Work Order ID 78860

Item Name: Crosstube Fwd

DRAWING NO. D206-667-141	TITLE CROSSTUBE ASS'Y (206B HIGH FWD)	REV. C	DART AEROSPACE LTD ENGINEERING ORDER		D.E.O. NO. D206-667-141-C-1	SHEET NO. SHEET 1 OF 1	SCALE NTS
DRAWN <i>q</i>	CHECKED <i>ASS</i>	MFG. APPR. <i>AD</i>	APPROVED <i>MD</i>		DE APPR. <i>HA</i>		
DATE 11.07.15	DATE 11.07.20	DATE 11.07.21	DATE 11/07/21		DATE 11.07.21

REPLACE MAGNOBOND WITH PROSEAL.

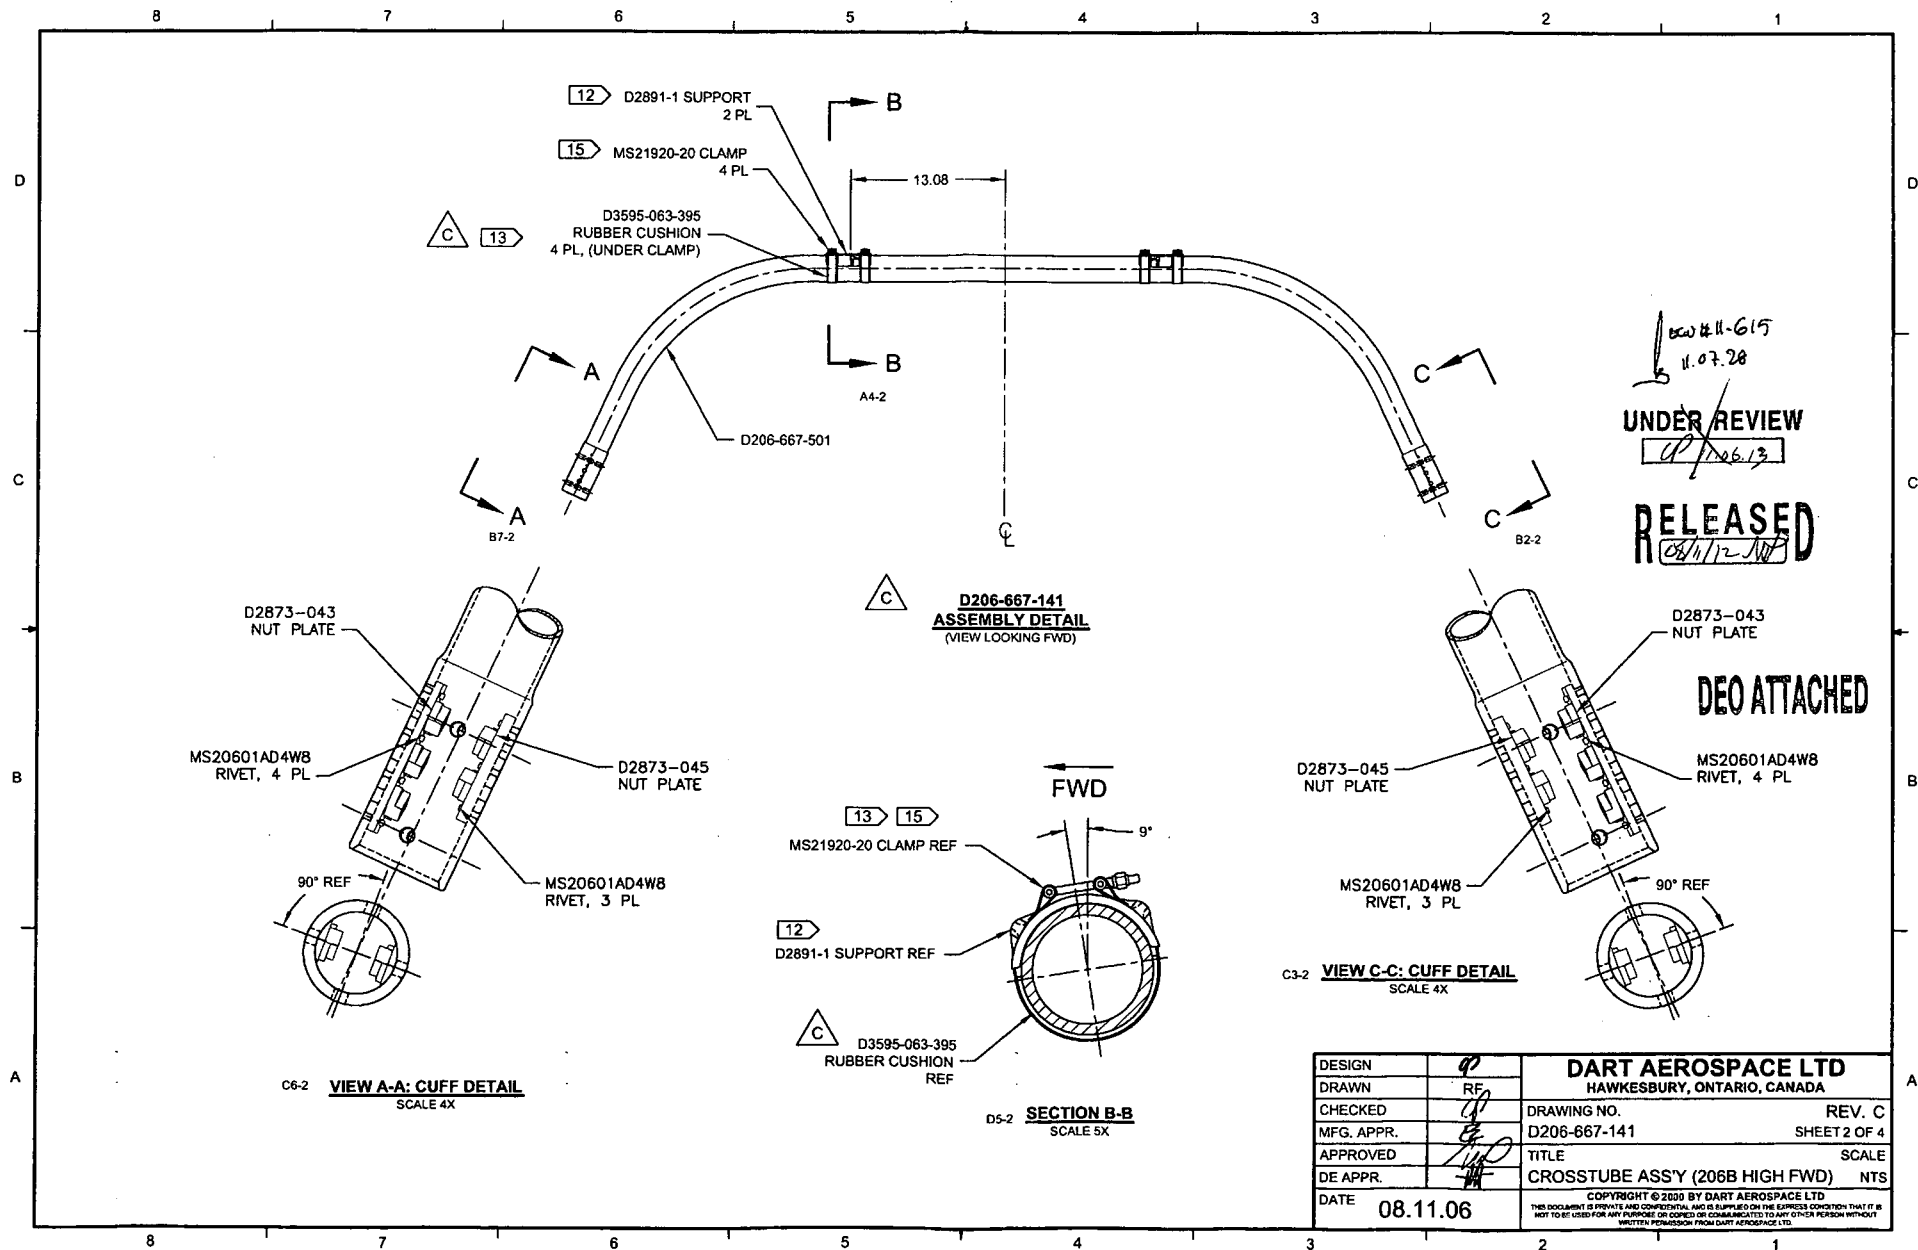
C	REVISE GENERAL NOTES/PART LIST (ZN D7-1); REORGANIZED VIEWS AND REFORMATTED DRAWING TO CURRENT STANDARDS. D3595-063-395 WAS D2856-400-694 (ZN D6-2 & A5-2); REMOVED REF. & ADD TOLERANCES (ZN C4-3, C5-3 & D3-3); RELOCATED FLAG #6 (ZN A8-3) PER NCR 210; MOVED TURNING DETAIL & UPDATED TOLERANCE TO SHEET 4.	RF	08.11.06
B	ADD HOLES AND NUT PLATES FOR COMPATABILITY WITH BHT/AA SKUDTUBES	PH	05.07.26
A	NEW ISSUE	CP	00.11.17
REV.	DESCRIPTION	BY	DATE
DESIGN	RF	DART AEROSPACE LTD HAWKESBURY, ONTARIO, CANADA	
DRAWN	RF	DRAWING NO. REV. C D206-667-141 SHEET 1 OF 4	
CHECKED	RF	TITLE SCALE CROSSTUBE ASSY (206B HIGH FWD) NTS	
MFG. APPR.	RF	DATE 08.11.06	
APPROVED	RF	COPYRIGHT © 2000 BY DART AEROSPACE LTD THIS DOCUMENT IS PRIVATE AND CONFIDENTIAL AND IS SUPPLIED ON THE EXPRESS CONDITION THAT IT IS NOT TO BE USED FOR ANY PURPOSE OR COPIED OR COMMUNICATED TO ANY OTHER PERSON WITHOUT WRITTEN PERMISSION FROM DART AEROSPACE LTD.
